Descripción general: El nuevo arnés en T FTI-STP1 requiere modificaciones para su uso en aplicaciones de transmisión automática (AT).

FTI-STP1: Notas de instalación y configuración

MODIFICACIÓN REQUERIDA PARA APLICACIONES DE TRANSMISIÓN AUTOMÁTICA ÚNICAMENTE

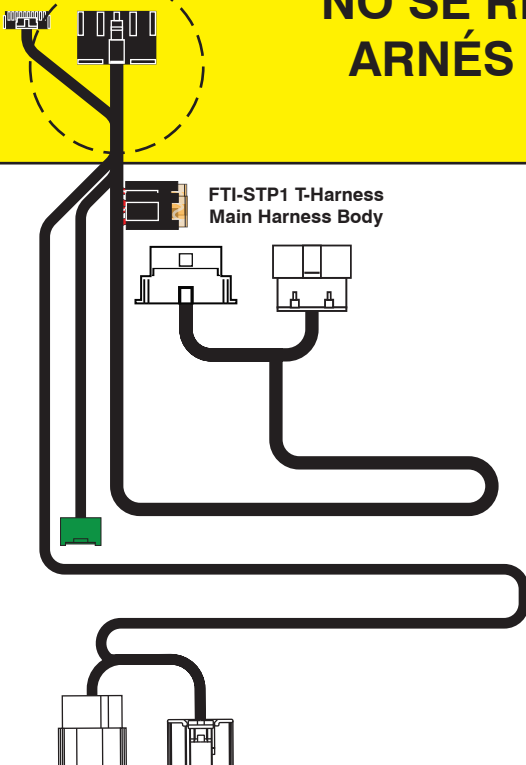
Problema: El arnés en T FTI-STP1 ha sido diseñado para ser compatible con AT (transmisión automática) y MT (transmisión manual), pero debido a una supervisión de la producción, el mecanismo de selección se estableció por defecto en el modo MT.

El uso de un arnés configurado para una aplicación MT, en un vehículo equipado con AT, podría provocar daños en el módulo del vehículo. Se recomienda que el arnés vuelva al modo AT antes de instalarlo en vehículos equipados con transmisión automática.

Corrección: Localice el cable rojo/negro (+ embrague) provisto en el conector CN1 del conjunto del arnés principal. Corte el cable rojo / negro, ya sea al ras del conector CN1 o dejando suficiente cable expuesto para que pueda aislar y asegure los extremos del alambre que quedan después del corte. Aísle cada uno de los extremos restantes del cable rojo/negro y asegúrelos para evitar cualquier posibilidad de cortocircuito.

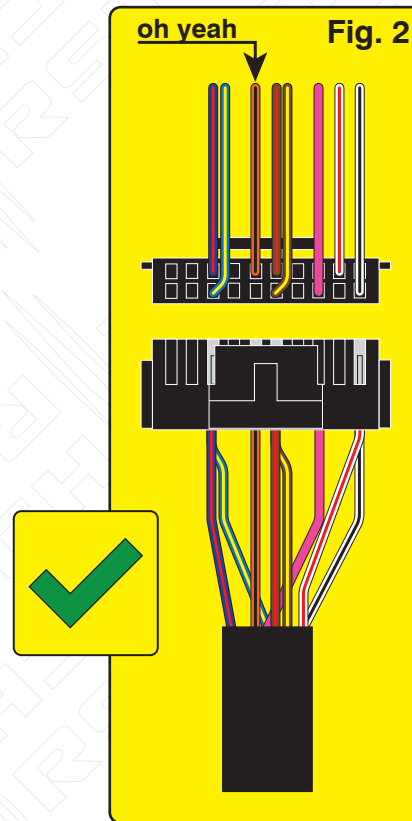
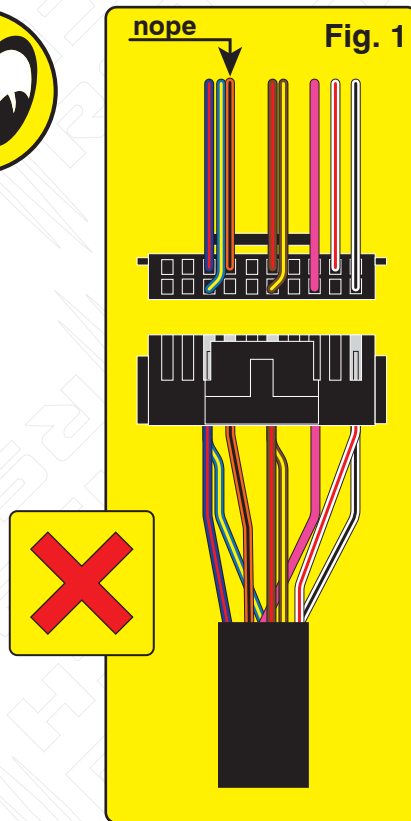
Overview: Production error; immobilizer wire (orange/black) in pin position #4 instead of pin position #5. Although an effort to correct the issue was made, some quantity of harnesses did get shipped before the issue was spotted. We are advising to inspect the harness BLADE connector before attempting to install the harness and program the module.

Issue: Module fails to program to vehicle, will not allow the vehicle to be remote started.

Correction: Step 1.) Locate the orange/black wire and confirm whether it is positioned as illustrated in Fig. 1 or Fig. 2. If the wire is as illustrated in Fig.1, proceed with Step 2 through 5 and complete the repair procedure outlined, if the wire is as illustrated in Fig. 2, correction is not necessary, proceed with harness installation and module programming.

Step 2.) Using a pick, lightly depress the catch that secures the terminal in the housing then remove the wire and terminal from the housing.

Step 3.) Using a fine tip razor or utility knife, insert the blade beneath the terminal catch and raise it slightly, so that it can be reused to secure the terminal when reinserted into the BLADE connector housing.

Step 4.) Refer to Fig. 2 for correct position of the orange/black wire (next to brown/red) then reinsert the terminal, pressing lightly until the catch 'snaps' into place, securing the terminal in the connector housing.

Step 5.) The repair is complete, proceed with installation and programming.
